Figure 3: Extract from Milestone Site Access Long Section Drawing 25103/007 with annotative protection detail marked up

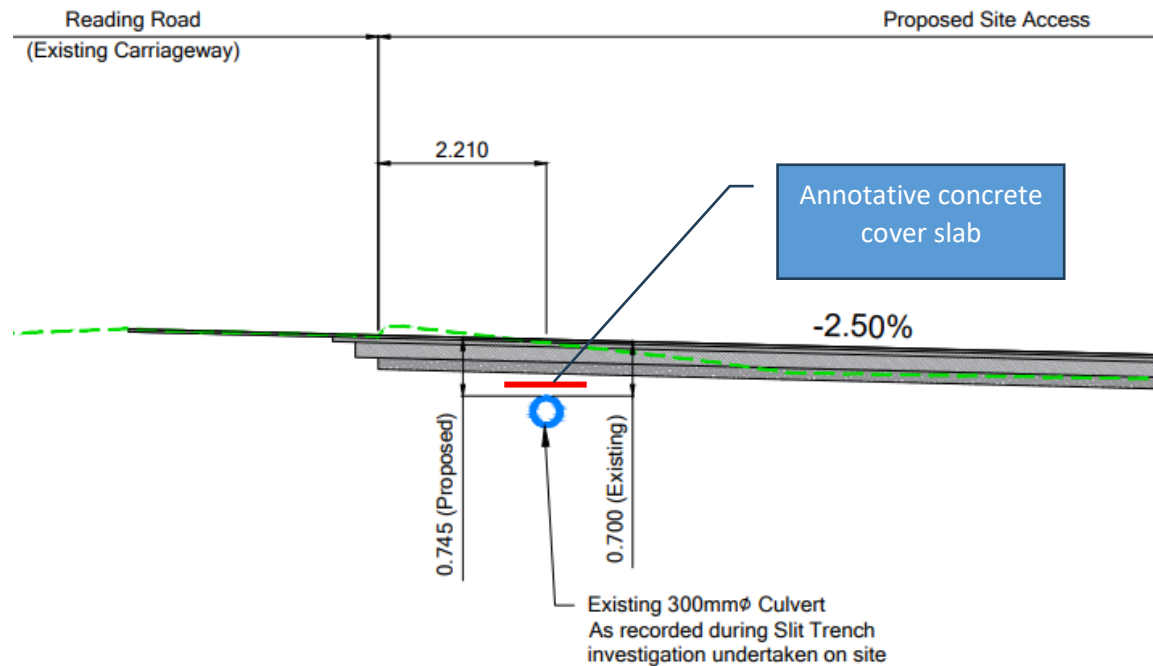
4. The finalised design of the protective detail will be subject to detailed design and will be subject to an Environmental Permit with the EA since the works will be within 8m of the Main River (albeit it an existing culvert).

5. There may also be an opportunity, subject to agreement with the EA, to provide a direct replacement for this section of the existing culvert to enable a repair of the displaced joints, all under the Environmental Permit. Such replacement of the existing culvert would not impact the existing flow regime of the culvert as it would simply be a replacement of the culvert with another of the same internal diameter.

6. In summary, there are various options for the provision of a protective detail to the existing culvert, or even replacement and the detailed engineering design detail can be secured by condition. As part of this condition the applicant could also arrange to carry out a further CCTV condition survey, during a “drier” period when the culvert is not running with as much flow.
